Re: Major Modification of the Federal TSCA PCB Chemical Waste Landfill Approval,
Wayne Disposal, Inc.; MID 048 090 633

Attachment: Excerpt from Major Modification Request, Figure 1, Proposed Master Cells VI-F and VI-G Layout

Figure 1. Proposed Master Cells VI-F and VI-G Layout

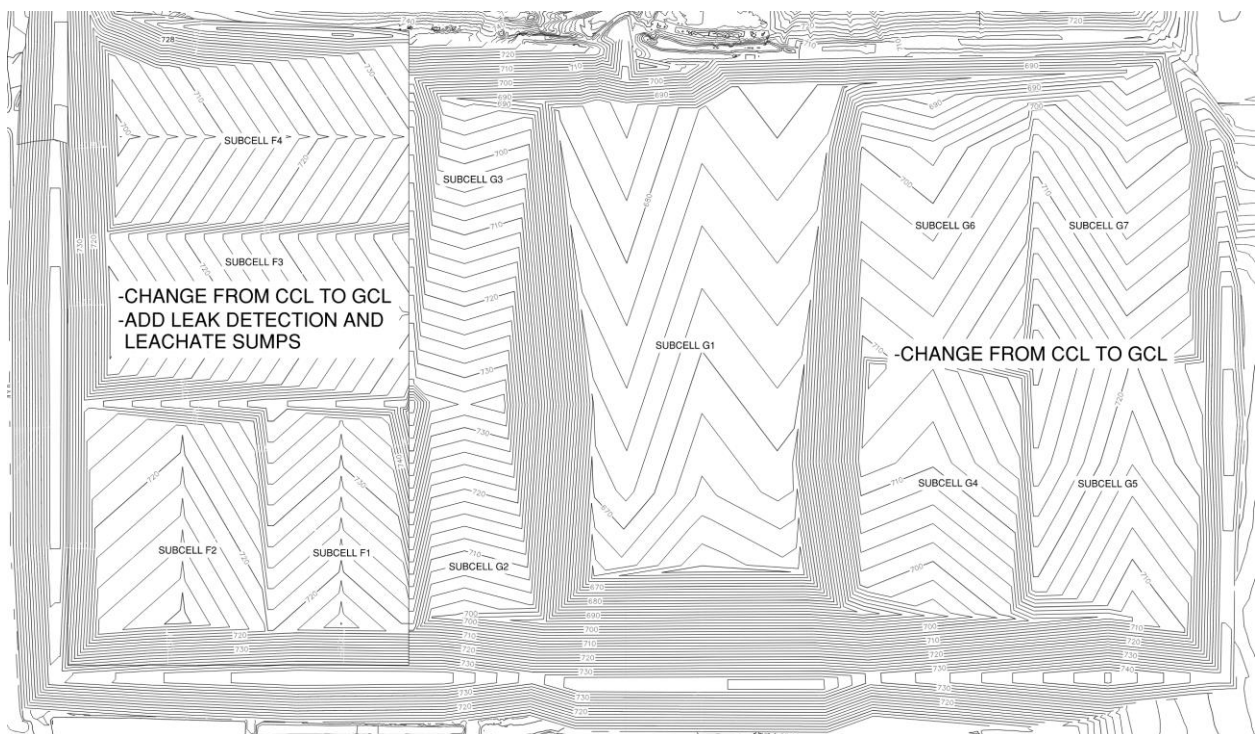
- GCL has superior resistance to freeze-thaw damage and is preferred considering Michigan’s climate
- GCL has superior resistance to settlement–induced tensioning
- GCL reduces the need for compaction and is more consistent in achieving the approved grades
- GCL has substantially lower hydraulic conductivity

Figure 1 outlines the proposed area of the base liner system upgrade from CCL to GCL in MC VI-F and MC VI-G, as well as associated changes to the baseliner grades and layout of MC VI-F.

This letter serves as an approval of a major modification to the TSCA PCB Chemical Waste Landfill February 14, 2019 Approval. Based on this approval, the engineering design description, drawings, and technical specifications for MC VI-G and MC VI-F in the January 21, 2021, major modification request and the July 16, 2021, liner grade revisions shall replace those in the March 29, 2018, Renewal Application for the WDI TSCA PCB chemical waste landfill that are referenced in the existing 2019 Approval.
